**Final  
Initial Study and  
Mitigated Negative Declaration**

**Ellwood Mesa Coastal Trails  
& Habitat Restoration Project**

City Case # 13-039-CUP  
14-MND-001

**CITY OF GOLETA**  
**FINAL MITIGATED NEGATIVE DECLARATION**  
**June 23, 2014**

**FIGURE 1**

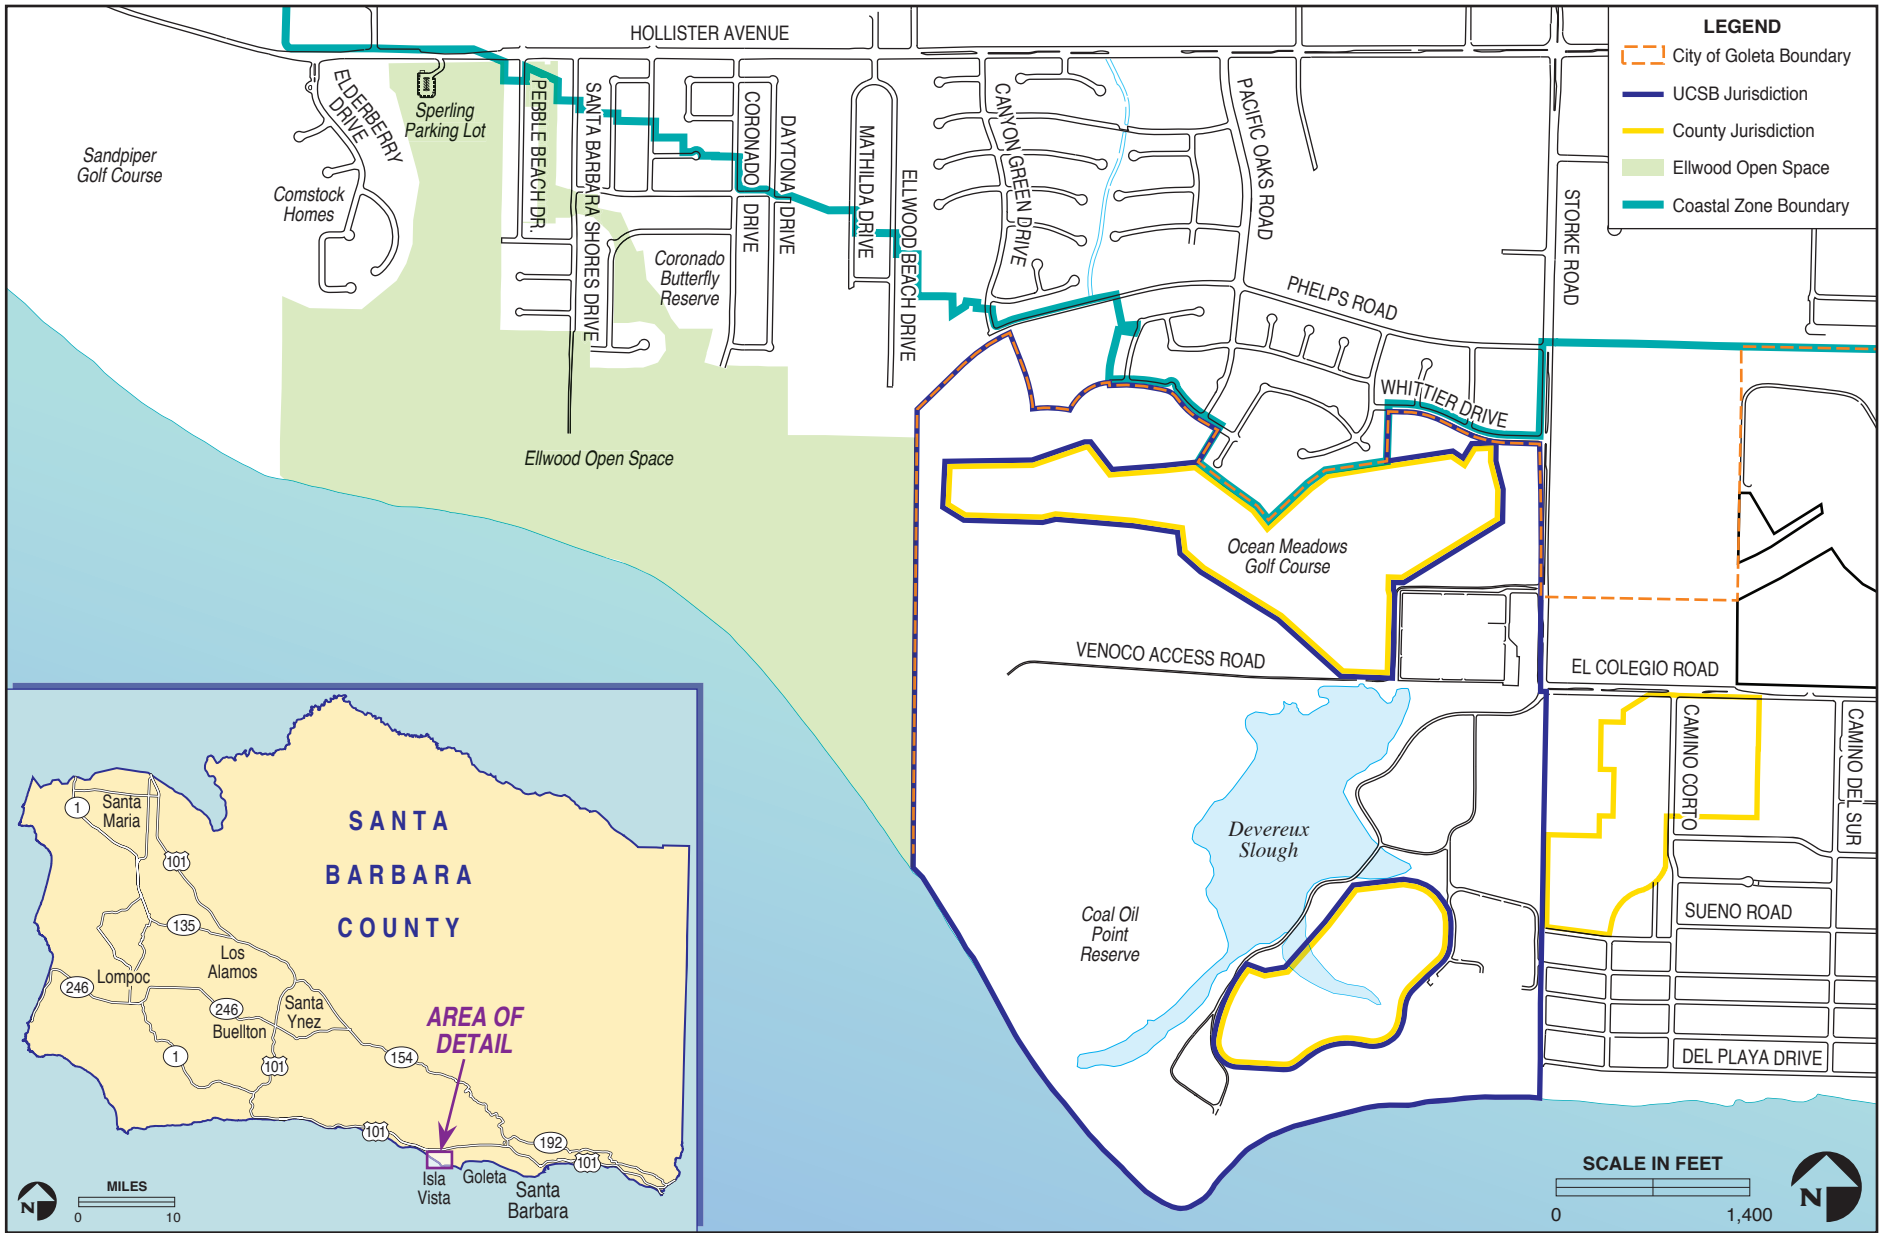
To clearly delineate all of the jurisdictions in the area, I suggest showing the County's jurisdiction on Figure 1. This would include the remainder parcel bordering the former golf course and Isla Vista.

*Response to Comment 1-1:* Comment incorporated. Figure 1 has been updated to include relevant County jurisdiction within the figure frame.

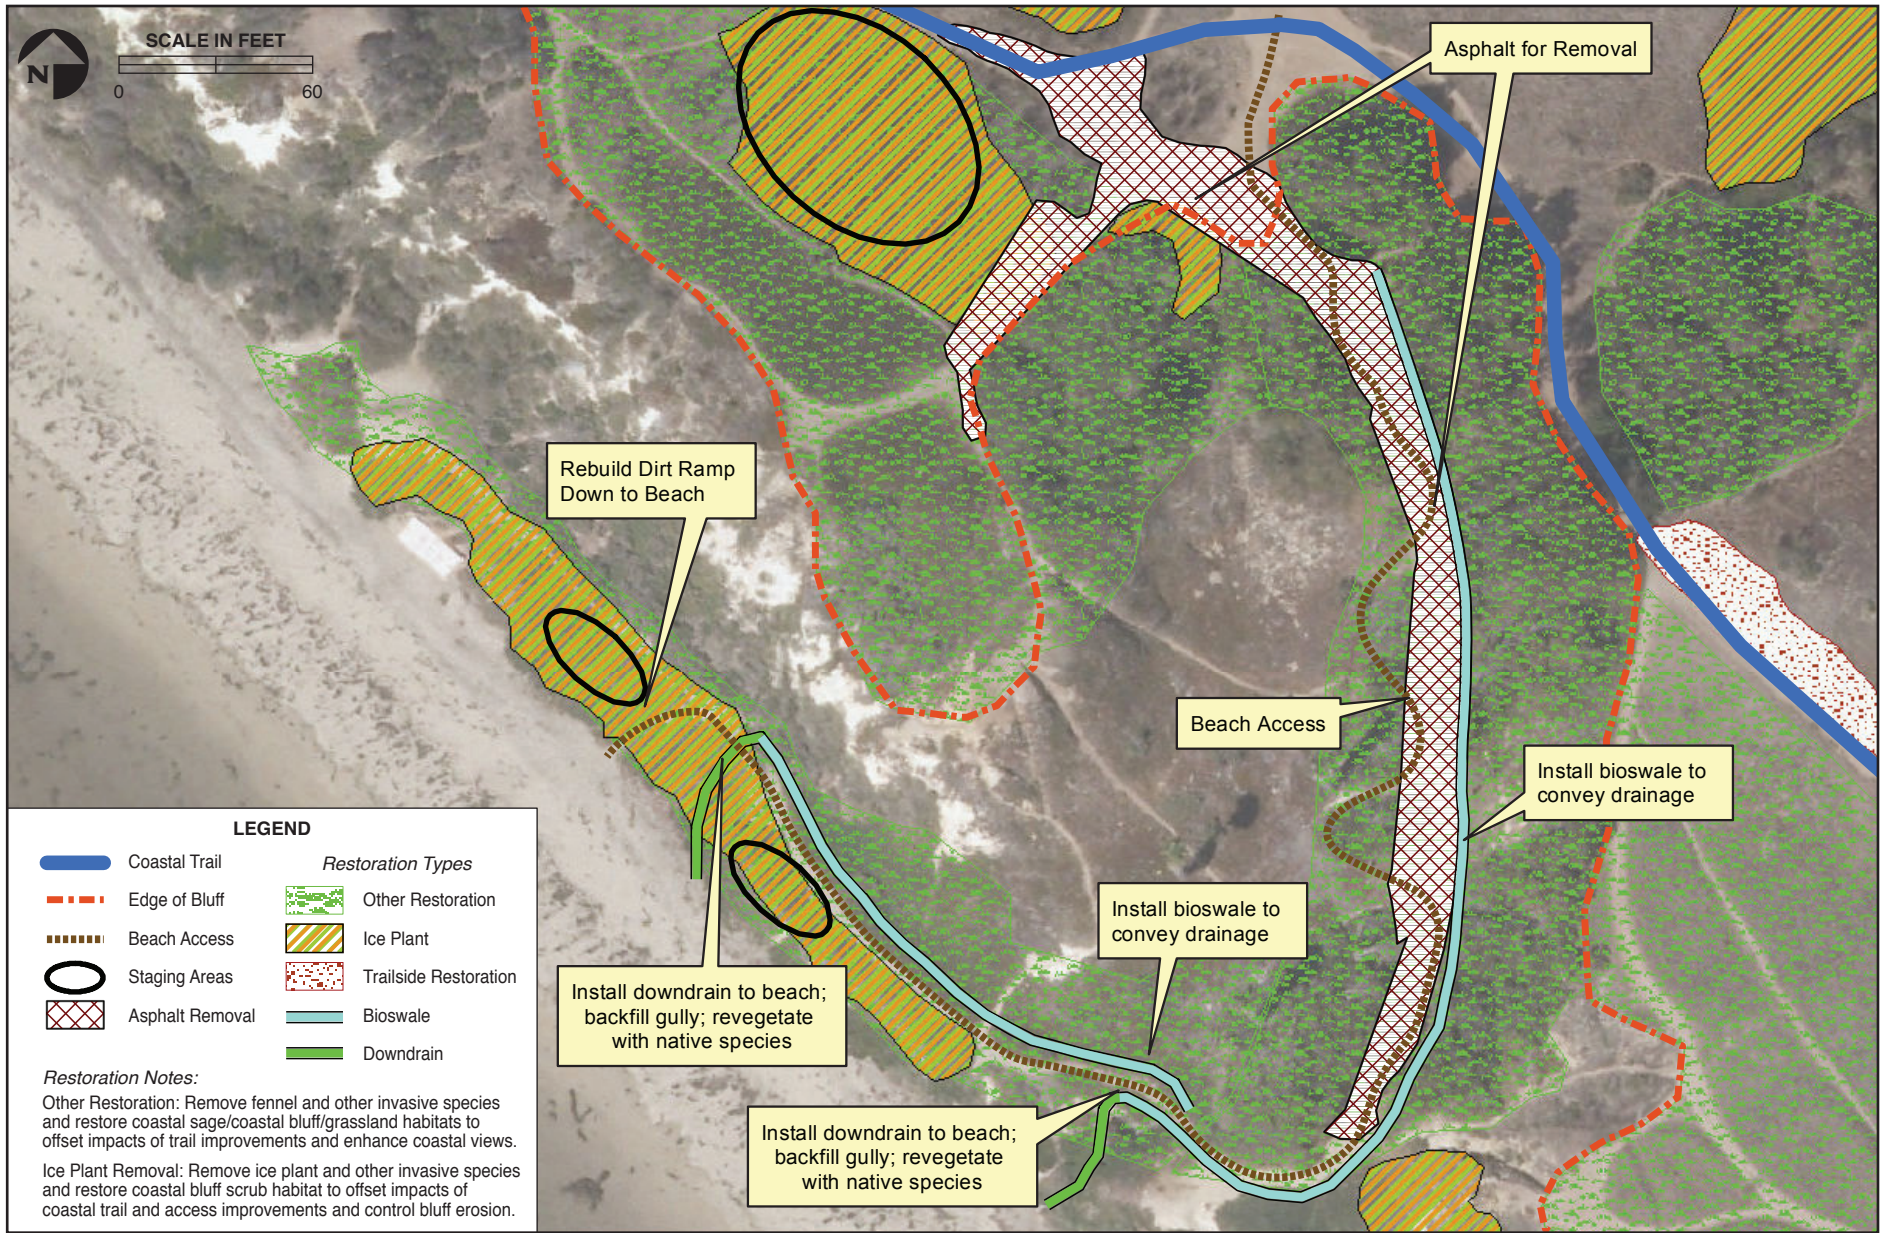
**Fig. 4** does **not** appear to be the actual depiction of **Coastal Access Point E**. **Figure 8** (Pg 70) is the **actual depiction**.

On Fig. 4 (Pg. 19) the asphalt for removal does NOT have the elliptical curve that access point E has. The large denuded area with the horizontal paths is nowhere to be seen when you are walking down the path of Access Point E. and on Figure 8. There are three palm trees, what appears to be an old fireplace and eucalyptus trees that do not appear on Fig. 4. (Pg. 19)

*Response to Comment 2-2:* Comment noted. Figure 4 and Figure 8 both depict Beach Access Point E; however, each figure shows a different view and is intended to convey a different aspect of the proposed Project elements at Beach Access Point E. Figure 4 is a plan view that is intended to depict the habitat restoration that would occur within the vicinity of Beach Access Point E as a result of the proposed Project. Figure 8 is an oblique aerial view of the existing access point that shows the approximate configuration of the proposed bioswales and downdrains, which would address long-term erosion-related issues.

*Response to Comment 2-3:* Comment noted. The location of the asphalt is based on mapping presented during the public outreach meeting on December 2012. The asphalt curves slightly as it descends down the bluff as depicted in Figure 4. Additionally, the denuded areas along the trail are associated with the vertical bluff face. This area appears adjacent to the trail as a result of the viewpoint in the figure. Further, this area may have been recolonized by bluff vegetation after the aerial photograph was captured (December 2013). Regardless, the intent of this figure is to show the areas in which restoration would occur under the proposed Project.

*Response to Comment 16-1:* Comment noted. The area of restoration at Beach Access Point E would strictly follow the limits in Figure 4. Eradication of invasive species outside of the identified restoration areas would not meet the scope or objectives for the proposed Project.
